Bay Area Municipal Transmission Group's Comments on the 2011 CTPG Draft Study Plan

August 5, 2011

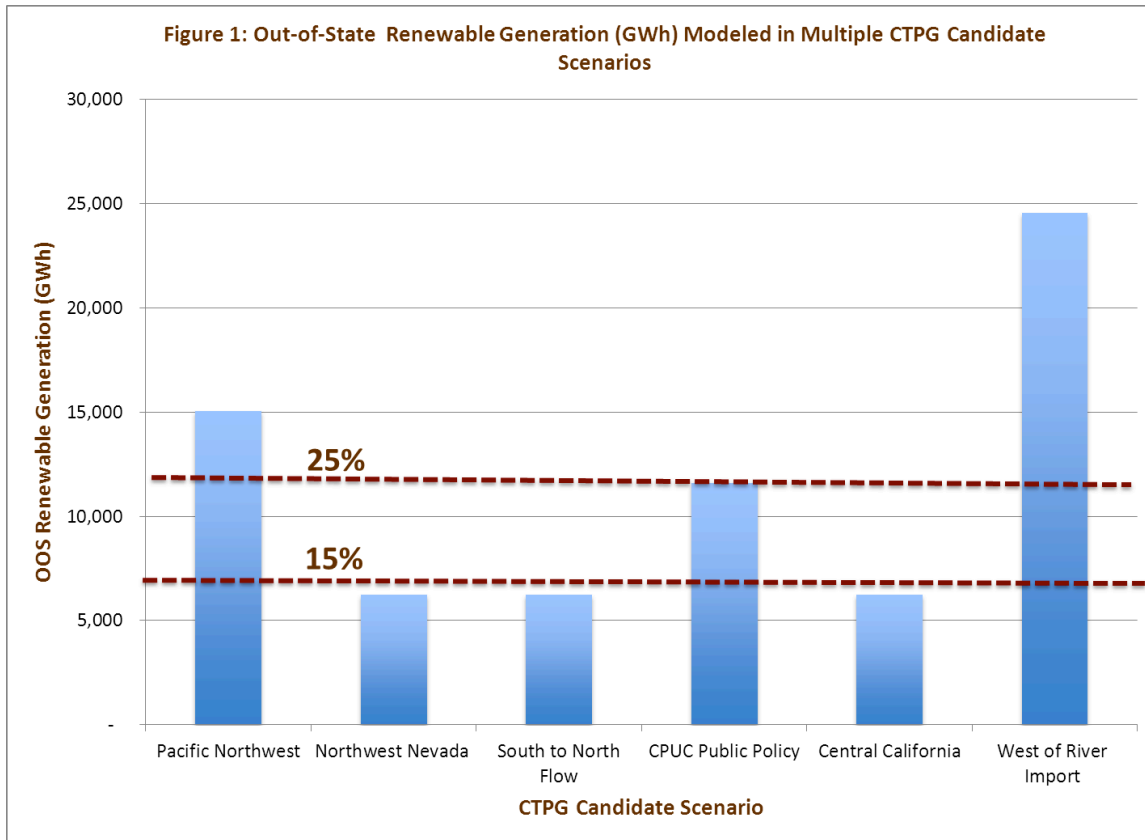
We suggest that in addition to the CPUC Public Policy scenario, i.e., *Cost-constrained* scenario, the CTPG should also study the CPUC *Environmentally-constrained* scenario. The latter is the only scenario that comes close to addressing the State's 12,000 MW Distributed Generation (DG) goal, which is a key part of Governor Brown's vision of the future and which all State regulatory agencies are working hard to achieve.² Selecting the *Environmentally-constrained* scenario as the Base Case is clearly the most appropriate from the standpoint of consistency with the State's energy goals because it is closest to correlating with the State's DG goal.

BAMx does not believe that the CTPG has modeled the CPUC *Cost-constrained* scenario accurately as far as the *Discounted Core* generation is concerned. The CPUC/E3 calculator provides first priority to the *Discounted Core* generation. However, it alters the *Discounted Core* to the extent it triggers additional significant transmission related costs that would overall make it economically inefficient. For instance, the Kramer and Pisgah CREZs have discounted core generation of 250MW (584GWh) and 500MW (1,169GWh), respectively. However, the CPUC *Cost-constrained* scenario restricts them to 62MW and 275MW, respectively to avoid any new significant transmission network upgrades. The CTPG does not implement the CPUC approach in this regard. Instead it assumes the entire *Discounted Core* generation in these CREZs as given. We encourage the CTPG to work with the CPUC staff in revising its modeling of the *Discounted*

Core renewable generation in the CPUC Public Policy scenario accordingly and in adding an *Environmentally-constrained* or DG scenario as recommended above.
